UNITED STATES PATENT AND TRADEMARK OFFICE

10/531,295

Office Action Summary	Application No. 10/531,295	Applicant(s) CASALE ET AL.	
	Examiner Daniel Tucker	Art Unit 3781

DETAILED ACTION

Fig. 1 of Adams et al.

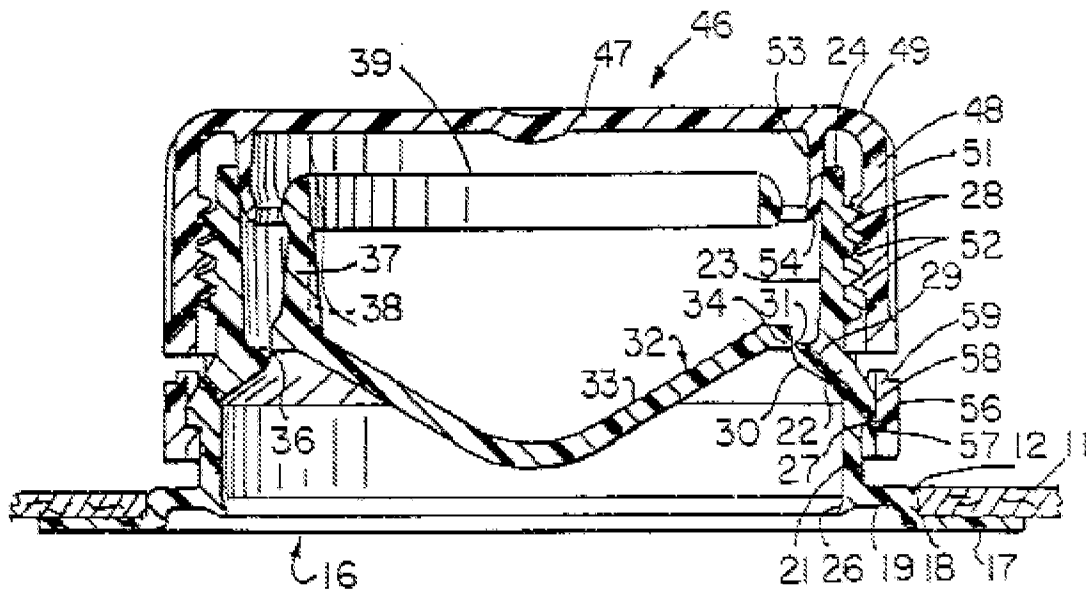
5. In re Claims 1 and 14, with reference to Fig. 1 above, Adams et al. discloses:

A sealed package for pourable food products,

having a closable opening device in turn comprising a frame (16) defining a pour opening (12) and fixed to said package (11),

a cap (46) fitted to said frame to close said pour opening and movable to free the pour opening, and

pull-off opening means (39) housed in said frame (16) and comprising a rigid plate (32) extractable from the frame (16), by pulling action.

6. Adams et al. does not disclose a removable portion and a pull tab of sheet material interposed between the removable portion and the rigid plate.

9. In re Claim 8, with reference to Fig. 1 above, Adams et al. discloses that the plate (32) is connected integrally to the frame (16) by breakable connecting means (31) defining a parting direction in which said plate (32) is parted from the frame, and which is parallel to an opening direction of said pull-tab.

10. In re Claim 9, with reference to Fig. 1 above, Adams et al. discloses that the plate (32) comprises a base portion (32); and a grip portion (39) projecting from said base portion (32) and accessible through said frame (16) when said cap (46) is removed from said pour opening.

11. In re Claim 12, with reference to Fig. 1 above, Adams et al. discloses said grip portion (39) is substantially ring-shaped (col. 3, line 40), projects from one end of said base portion, and is bent over the base portion.

Fig. 4 of Granovsky

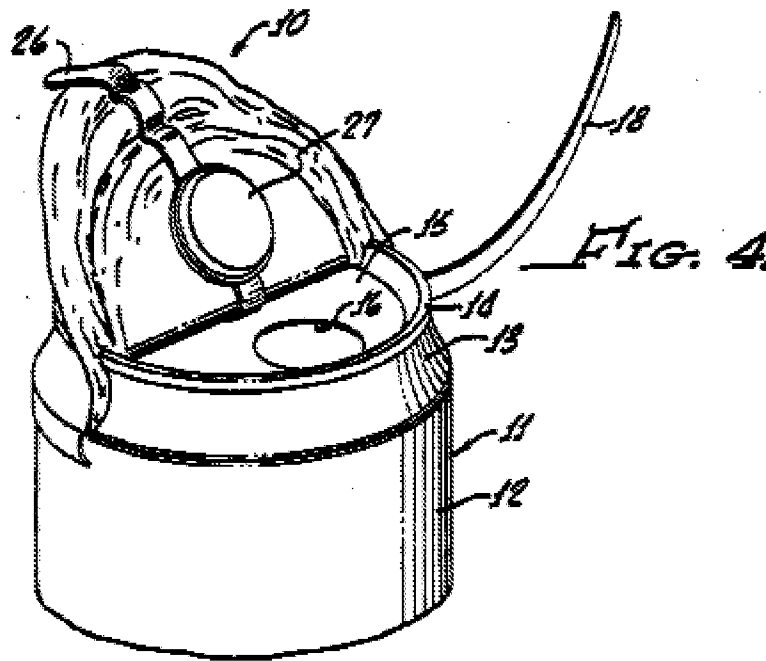
7. However, with reference to Fig. 4 above, Granofsky discloses a removable portion (27) and a pull tab of sheet material (26).

8. Thus, it would have been obvious one having ordinary skill in the pertinent art at the time the invention was made to have modified the package disclosed by Adams et al. to have a removable portion and a pull tab of sheet material in order to provide a sanitary cover for the opening.

Fig. 1 of Colby

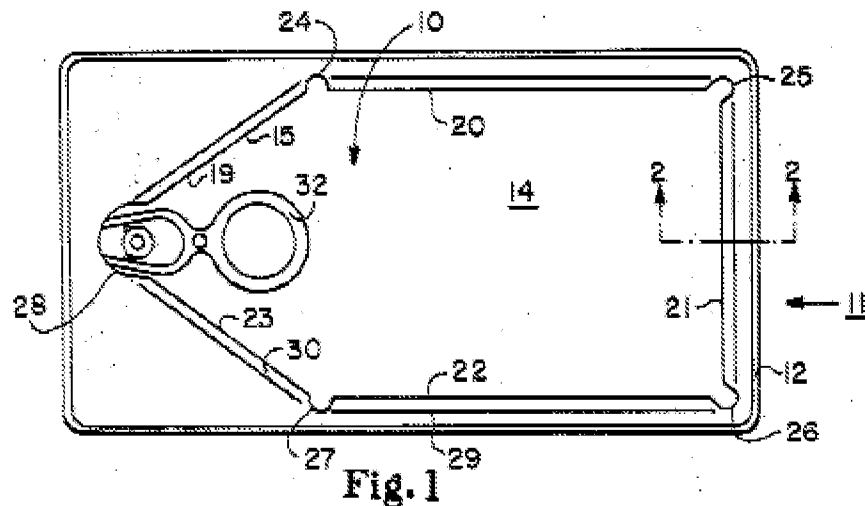
16. However, with reference to Fig. 1 of Colby above, Colby discloses breakable connecting means comprising two parallel strips of breakable material (20, 22).

17. Thus, it would have been obvious to one having ordinary skill in the pertinent art at the time the invention was made to have modified the package disclosed by Adams et al. in view of Granofsky to have two parallel breaking strips as taught by Colby for the predictable result of connecting the base portion of the plate to the frame in a parallel manner.

31. However, with reference to Fig. 1 of Colby above, Colby discloses breakable connecting means comprising two parallel strips of breakable material (20, 22).

Fig. 1 of Hardt

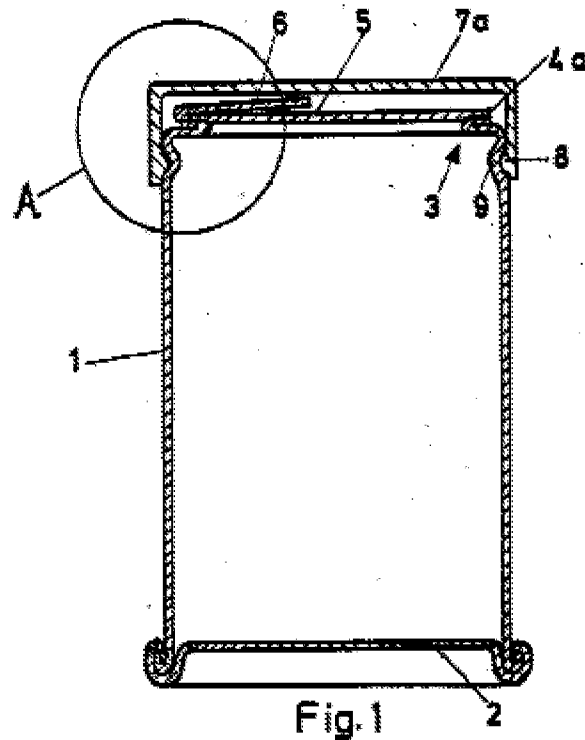
25. However, with reference to Fig. 1 of Hardt above, Hardt discloses a pull-tab that comprises an end portion (6) that is folded over a main portion (5).

26. Thus, it would have been obvious to one having ordinary skill in the pertinent art at the time the invention was made to have modified the pull-tab disclosed by Adams et al. in view of Granofsky to comprise an end portion that is folded over a main portion as taught by Hardt in order to achieve the predictable result of having a folded pull-tab.
